SSM 72313 - L405 & L494 Fuel Filling Difficulties

L405 & L494 Range Rover & Range Rover Sport Fuel Filling Concerns

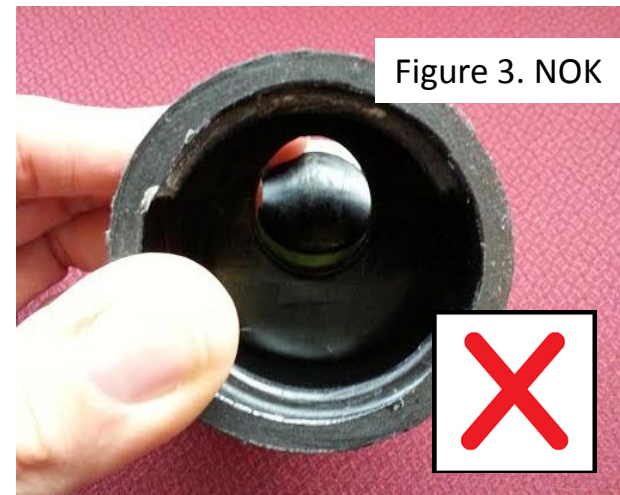
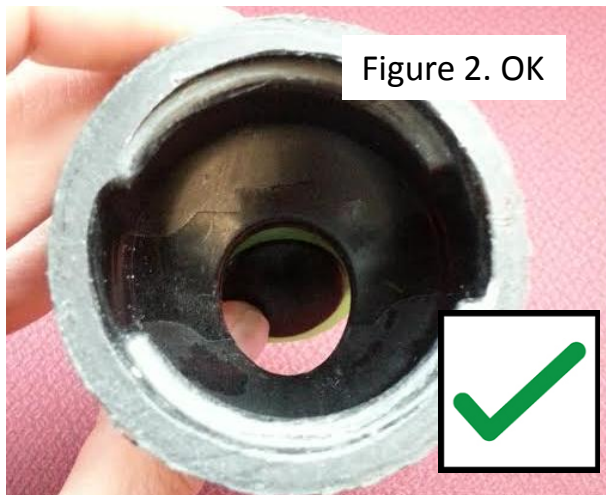
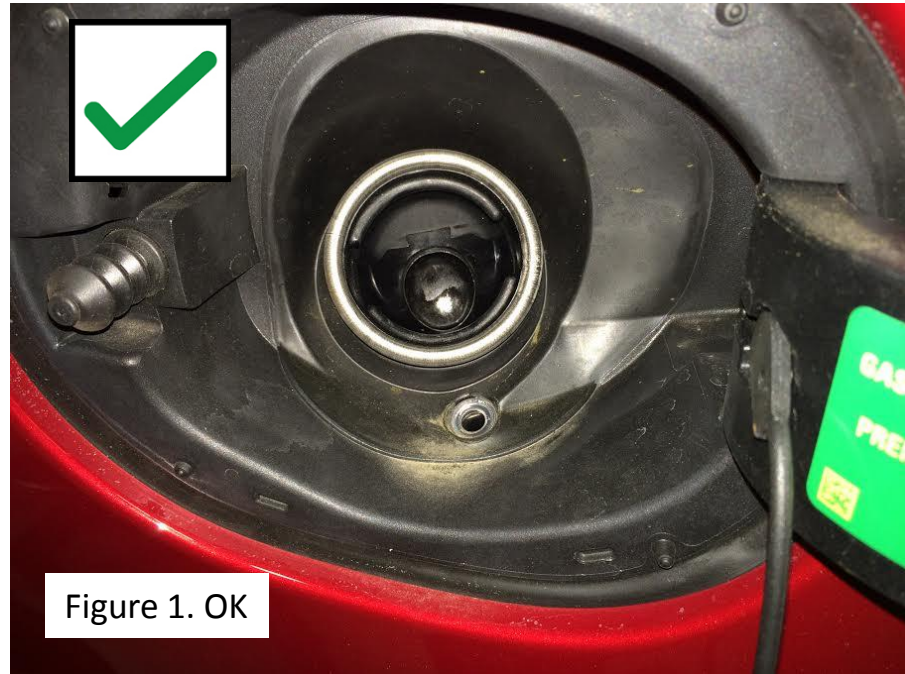
Reports have been submitted showing debris in the filler pipe was causing an obstruction and fuel filling problems.

Debris can be identified using a borescope (no need to remove the fuel filler pipe).

See the examples below:

- ONLY REPLACE THE FUEL FILLER IF A CLEAR FAULT IS OBSERVED. REPORT THE FAULT FOUND ON AN EPQR.
- If cause 1 is identified, correctly install the anti-siphon device.
- If cause 2 is identified, replace the fuel filler pipe (ensure the filler head is in the correct orientation on the new part).
- If cause 3 is identified, reroute the fuel pipe in the tank to prevent the check valve from being obstructed. Also take care to ensure the fuel sender is not obstructed.
- Fill with fuel and check to see if the issue is repaired. If so, report the fault found and fixed on EPQR. If not, raise a TA for further assistance to identify the fault.
